MODEL: GARDEN 9 ELEVATION: 1
BEDROOMS: 3
OPTIONS: N/A, ALT 2ND FLOOR (4 BEDROOM)

CITY OF CAMBRIDGE BUILDING DIVISION

2490 CORNER LOTS GARDEN 9 (GR) ELEVATION 1 A1 PACKAGE O.REG. 332/12

BARLASSINA CONSTRUCTION
CITY OF CAMBRIDGE

BASEMENT PLAN EL-1
BARLASSINA CONSTRUCTION
 CITY OF CAMBRIDGE

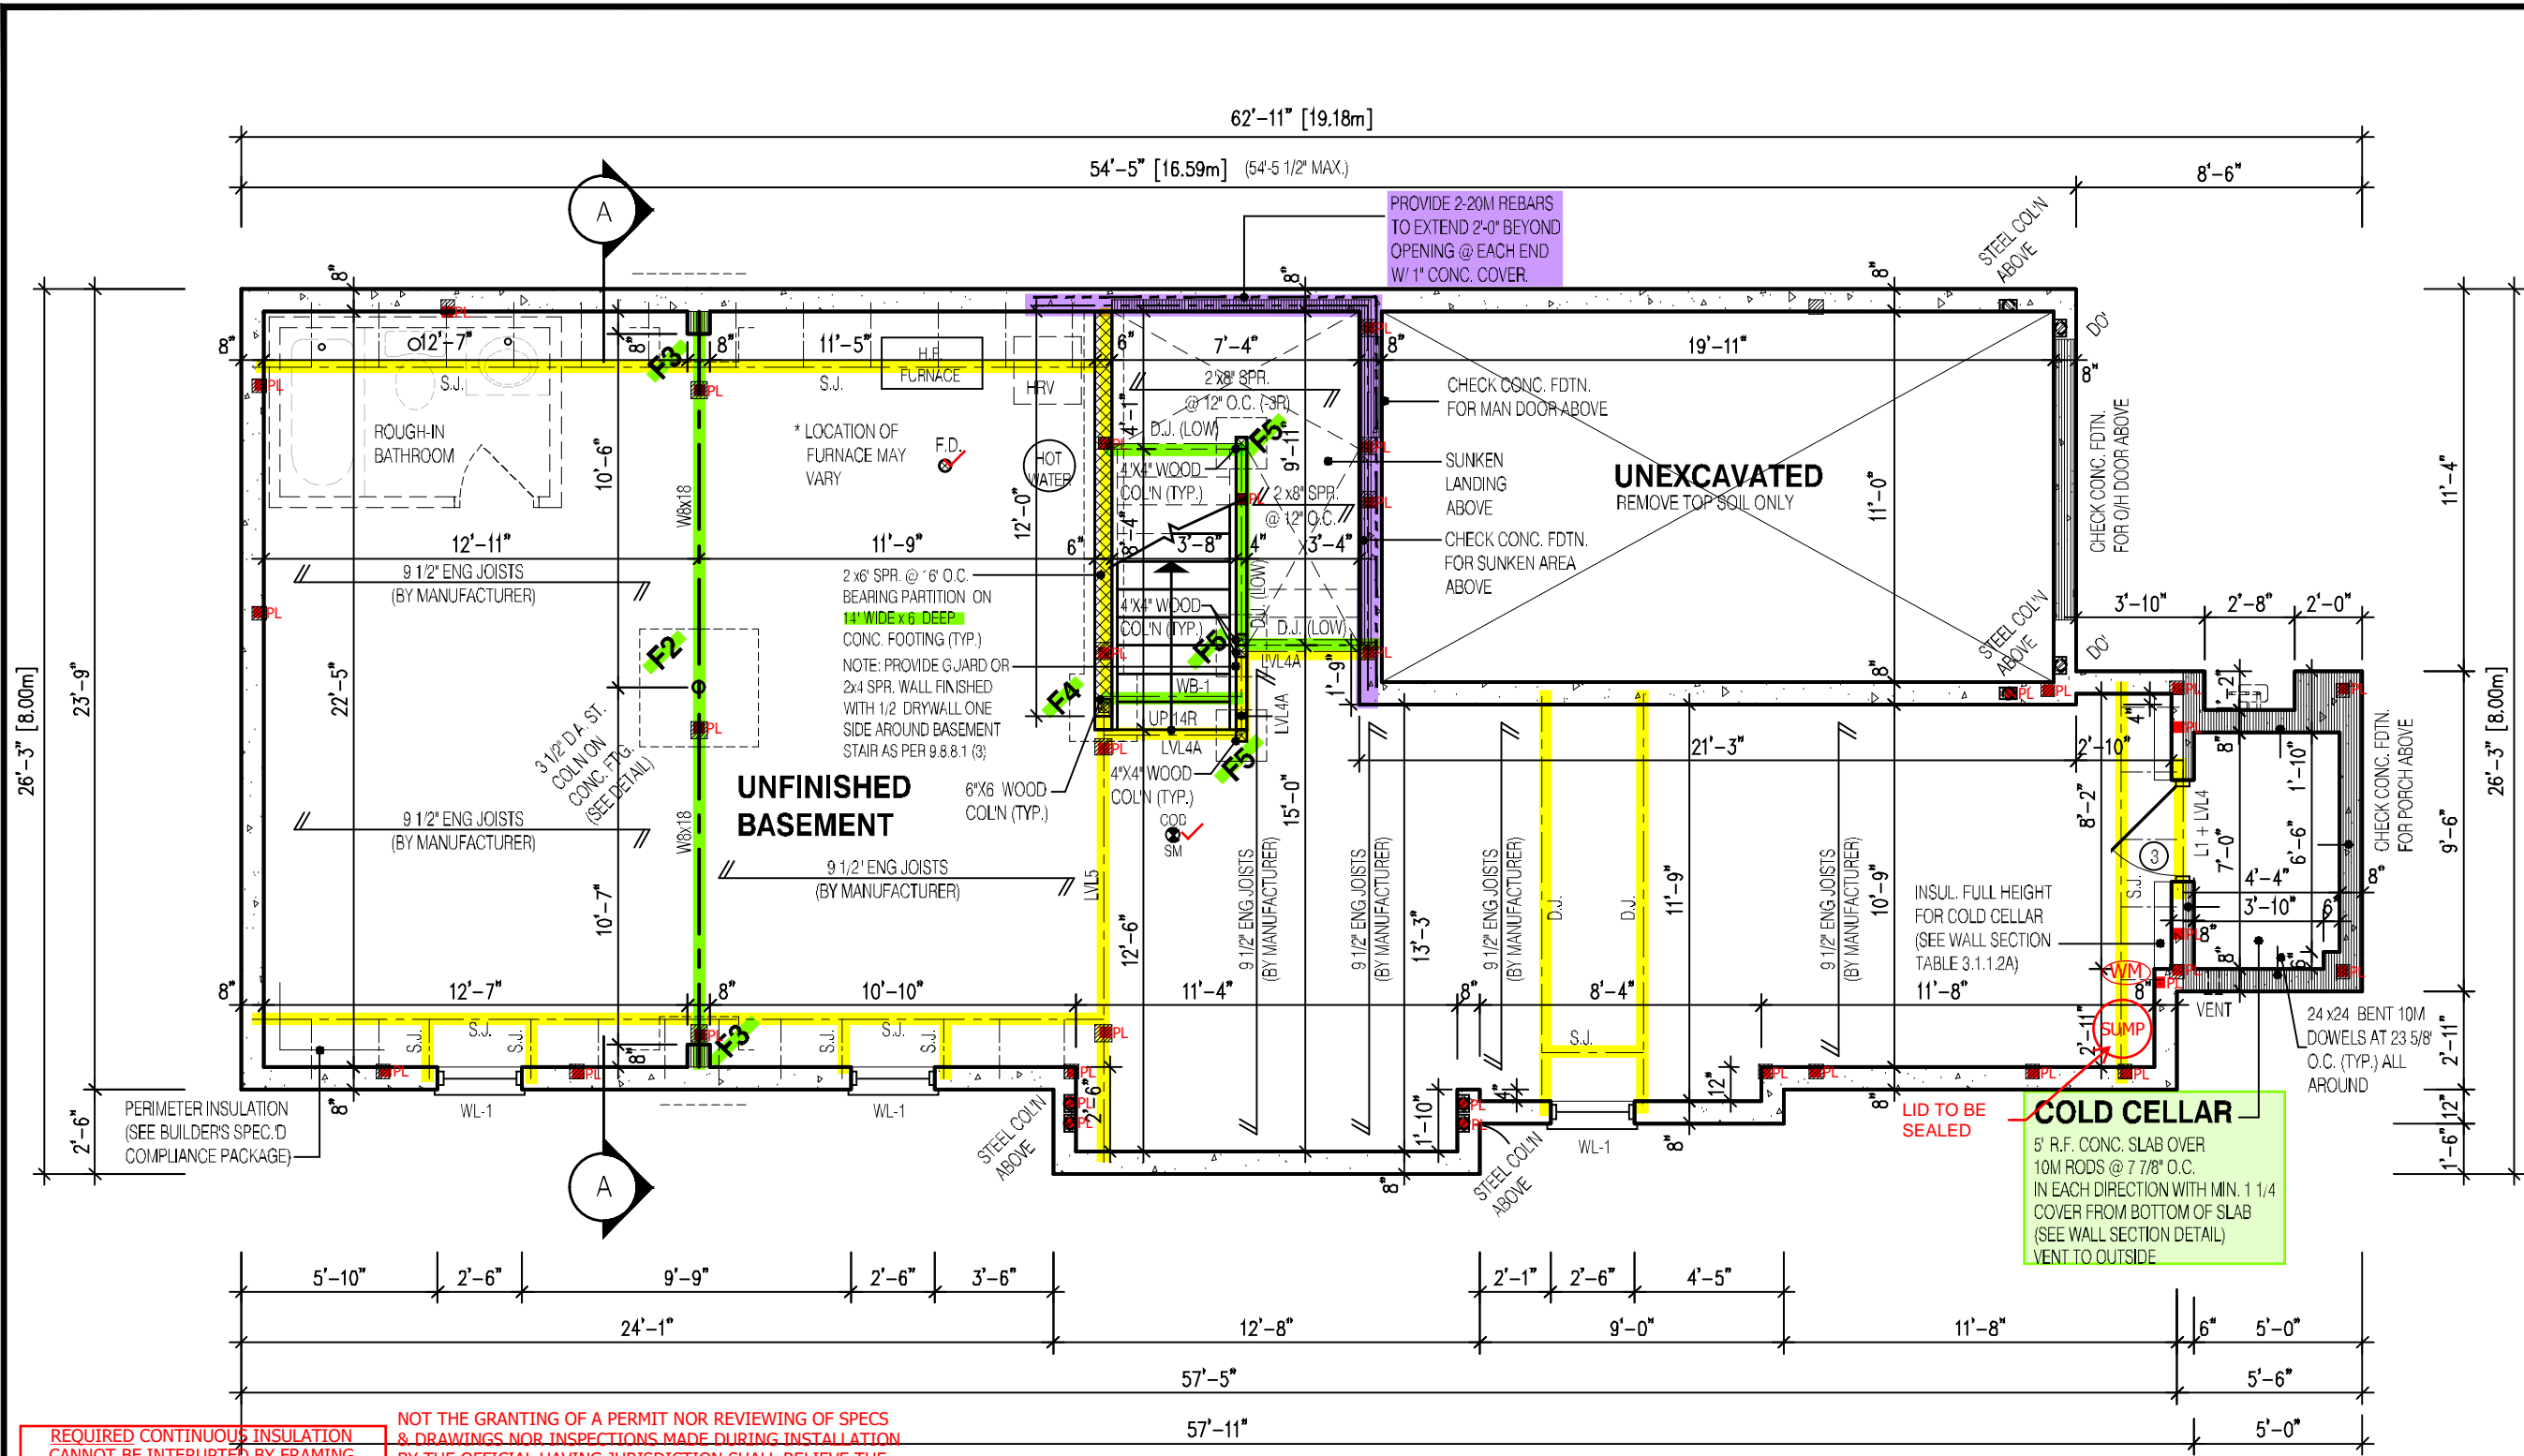
REQUIRED CONTINUOUS INSULATION CANNOT BE INTERRUPTED BY FRAMING MEMBERS SUCH AS STUDS

NON-LOAD BEARING WALLS NOT PERMITTED TO BE FRAMED (TYP.)

3 1/2" x 3 1/2" x 1/4" STEEL BRICK ANGLE TYPICAL UP TO MAX. 8'-1" SPAN
VERIFY WATER METER AND DWHR UNIT LOCATION WITH INSPECTOR
SPRAY FOAM/RIGID INSULATION TO BE PROTECTED AS PER 9.10.17.10.(1)

WATER METER TO BE INSTALLED WITHIN 2m (6'-6") FROM THE POINT THE WATER SERVICE PIPE MEETS THE BUILDING LINE

Walter Botter *Walter Botter* 21031
 NAME SIGNATURE BCIN
 REGISTRATION INFORMATION
 Required unless design is exempt under Division C, Subsection 3.2.4 of the building code.
 jardindesigngroupinc. 27763
 FIRM NAME BCIN
FIRST FLOOR PLAN EL-1
 BARLASSINA CONSTRUCTION
 CITY OF CAMBRIDGE

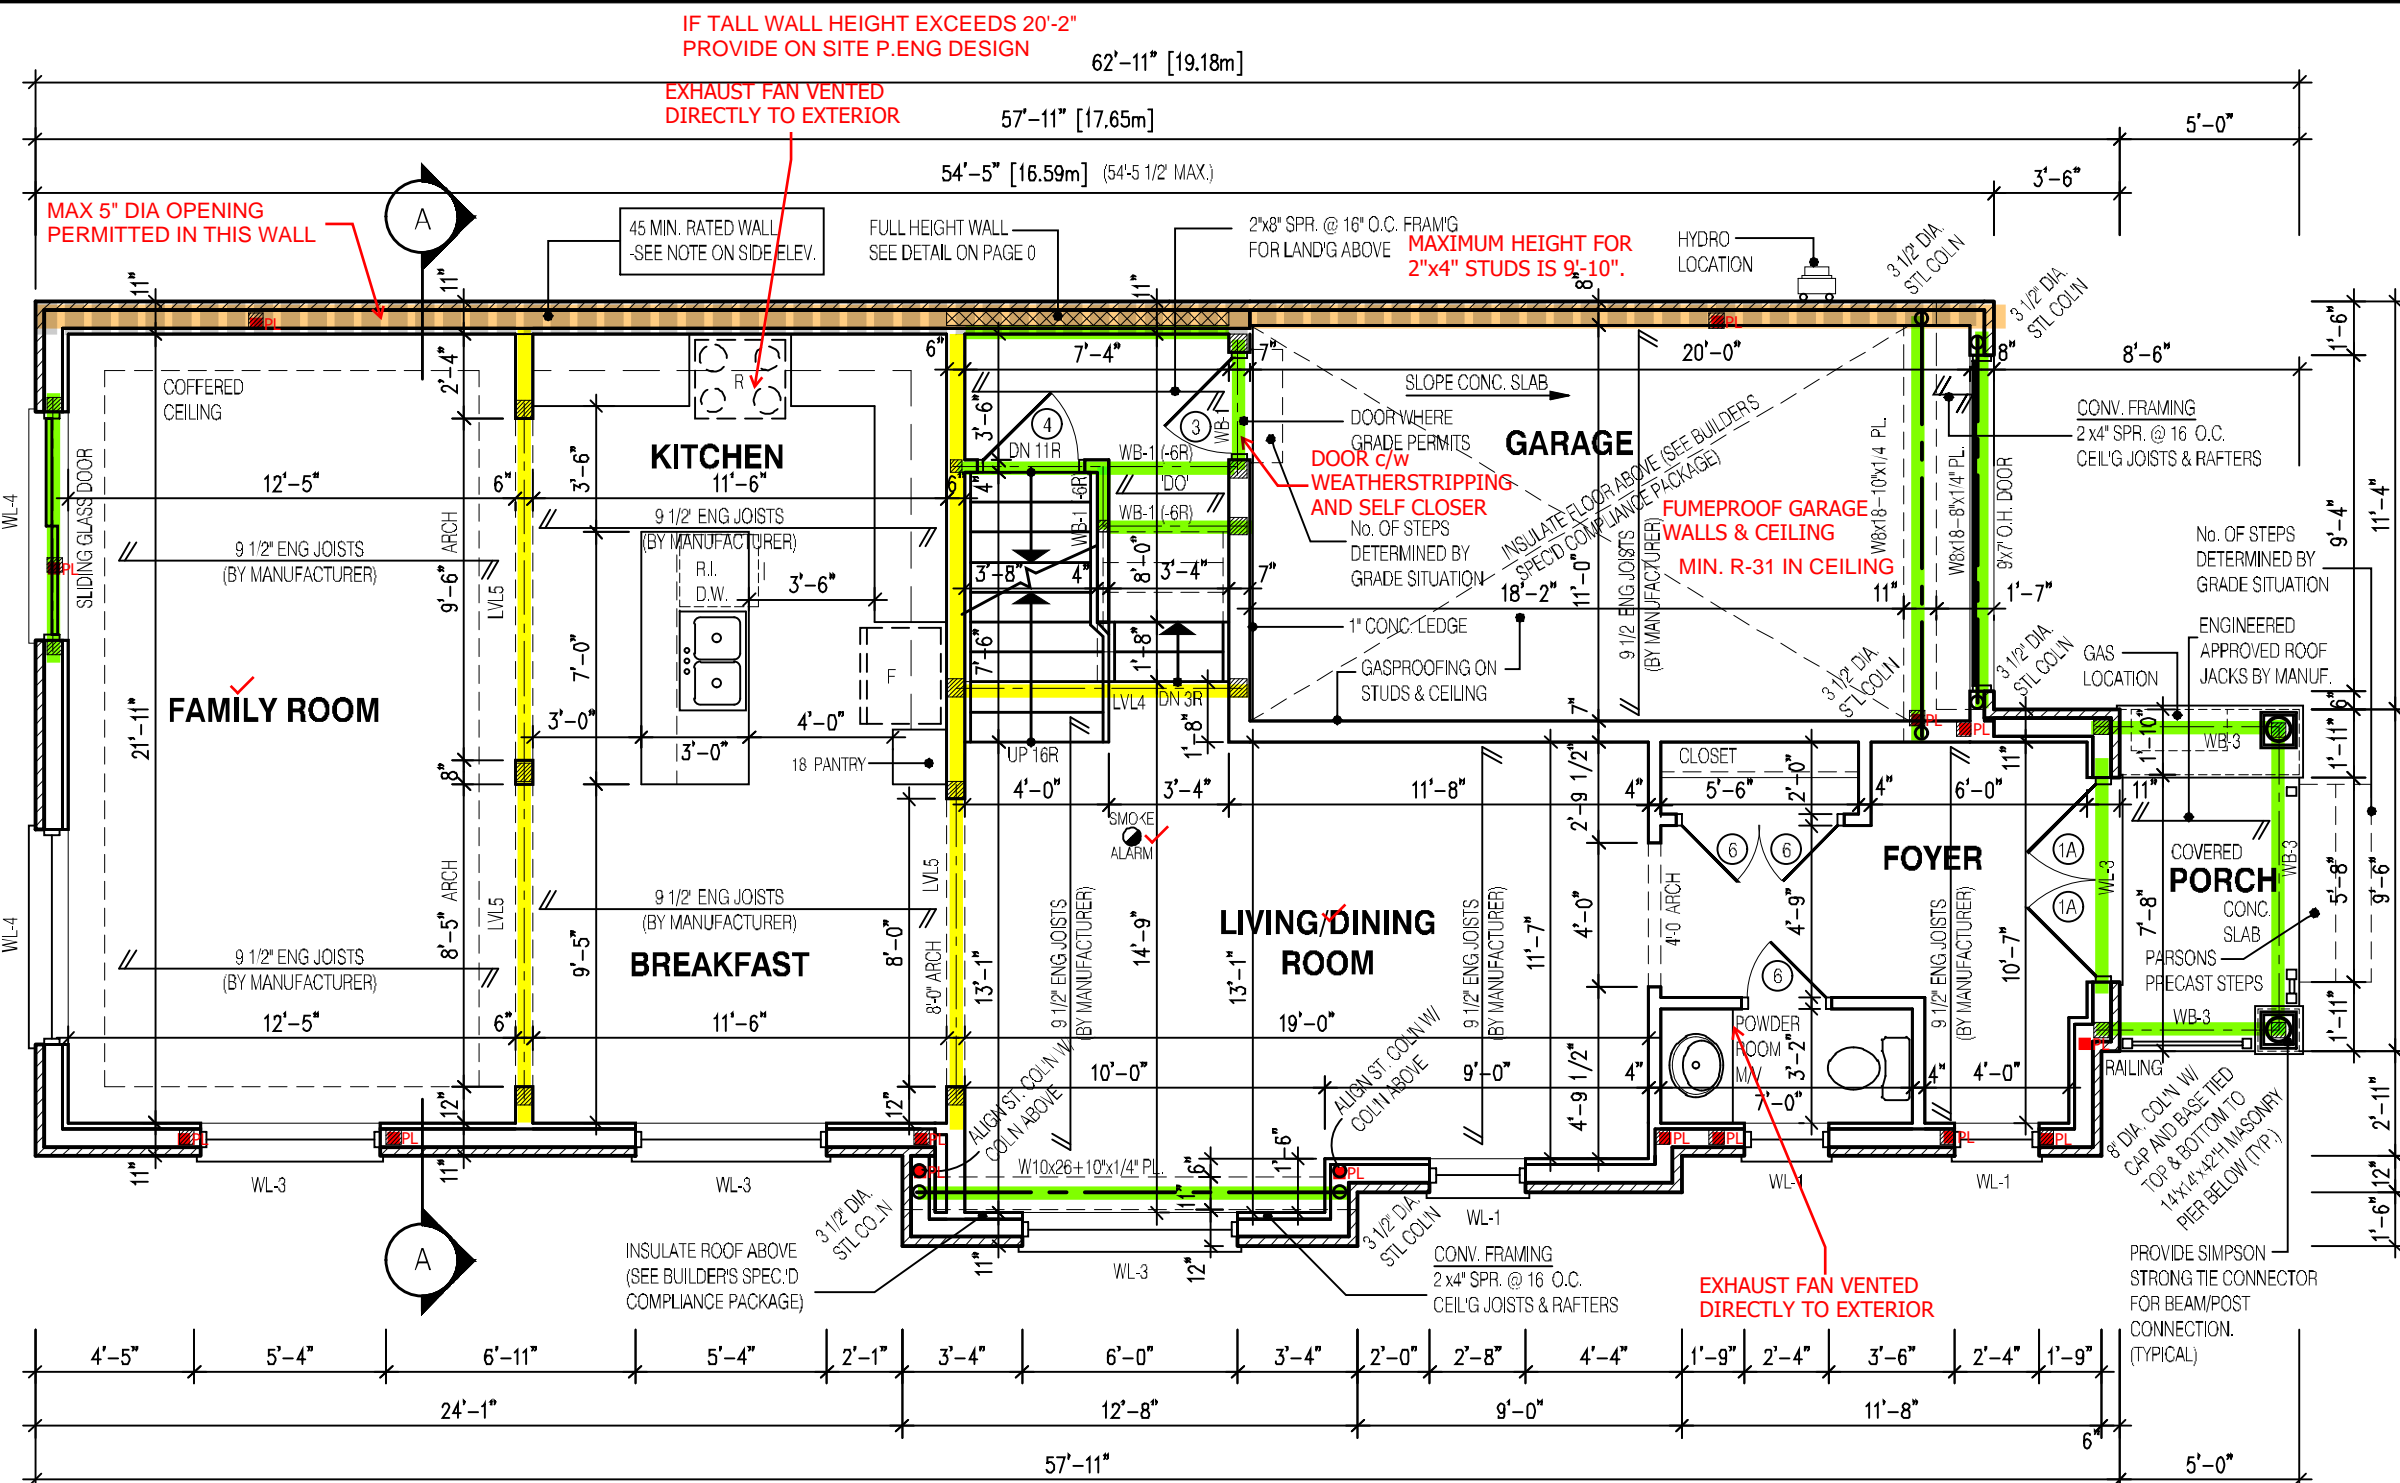
*TRACE ALL POINT LOADS THROUGH FLOOR SYSTEM TO SOLID BEARING BELOW

A LANDING IS REQUIRED AT THE ENTRANCE FROM AN ATTACHED GARAGE WHEN THERE ARE MORE THAN 3 RISERS BETWEEN THE GARAGE FLOOR AND THE INTERIOR FLOOR LEVELS IN ACCORDANCE WITH 9.8.6.2.(3)(a). GUARDS CONFORMING TO O.B.C. 9.8.8. & SB-7 ARE REQUIRED WHEN LANDING EXCEEDS 24" ABOVE GARAGE FLOOR

SEC. FLOOR PLAN EL-1
BARLASSINA CONSTRUCTION
CITY OF CAMBRIDGE

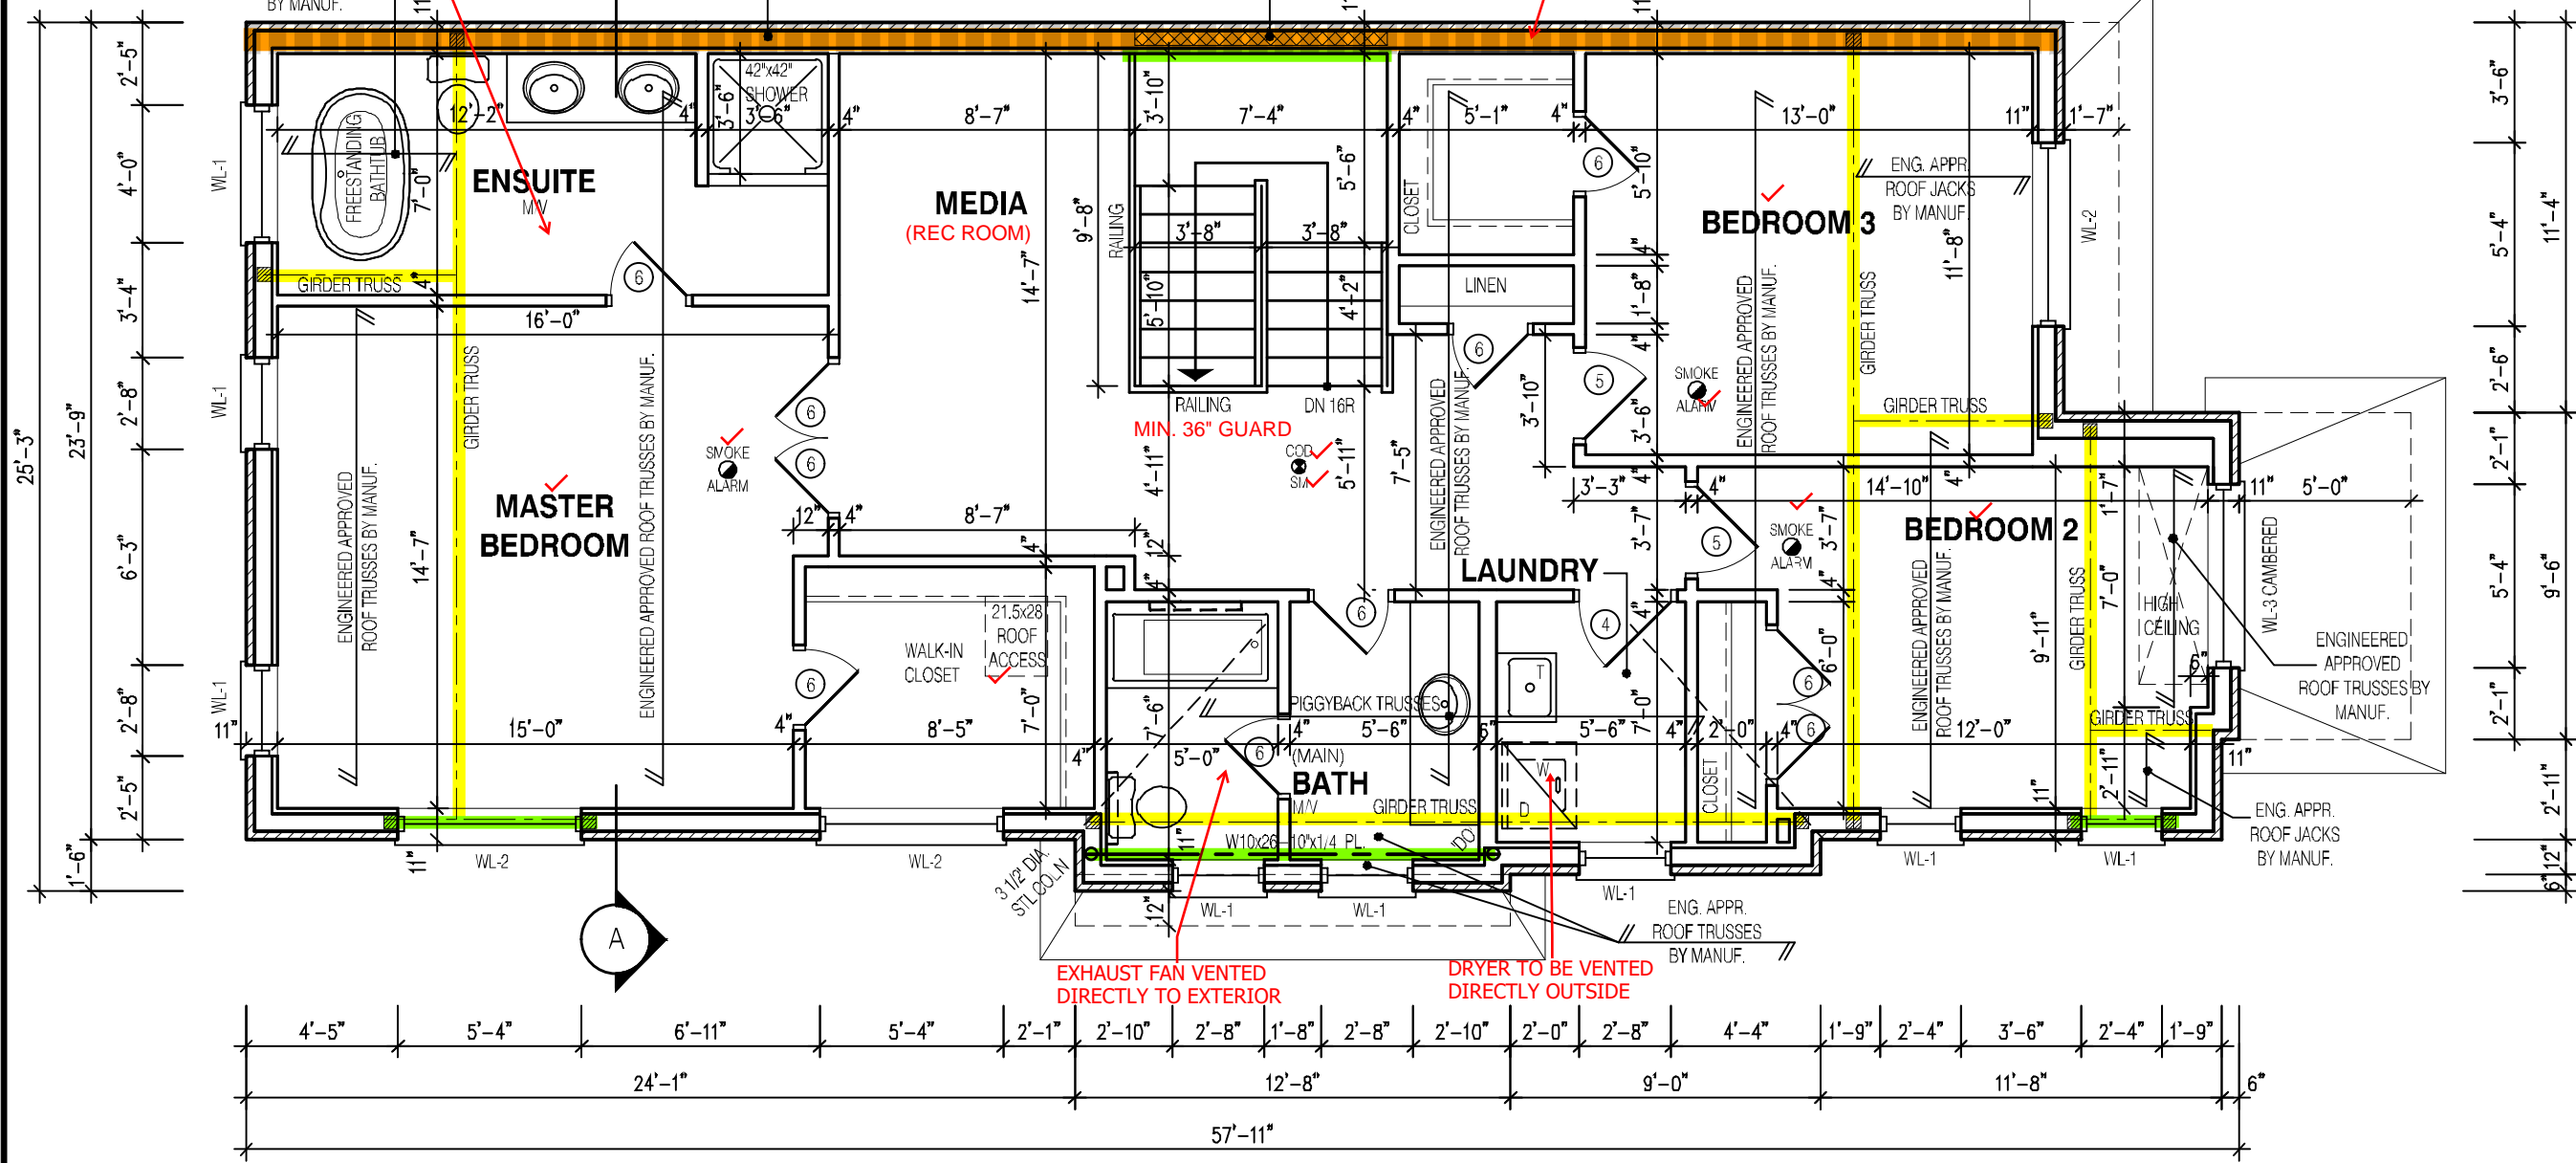
1 WINDOW SHALL PROVIDE AN UNOBSTRUCTED AREA OF 3.8SF w/ NO DIMENSION LESS THAN 15". WINDOW SILL TO BE MAX 39-3/8" ABOVE FINISHED FLOOR.

MAIN BATHROOM TO HAVE STUD BLOCKING FOR FUTURE INSTALLATION OF GRAB BARS ADJACENT TO SHOWER/TUB AND TOILET.

EXPOSED BUILDING FACE REQUIRES A 45MIN F.R.R. w/ 5/8" TYPE "X" DRYWALL & STUDS FILLED w/ INSUL. HAVING A MASS NOT LESS THAN 1.22 KG/M² WHERE LIMITING DISTANCE < 1.2m

MINIMUM 16" WATERPROOF FINISH REQUIRED ABOVE RIM OF TUB TO WINDOW SILL

IF TALL WALL HEIGHT EXCEEDS 20'-2" PROVIDE ON SITE P.ENG DESIGN

MAX 5" DIA OPENING PERMITTED IN THIS WALL
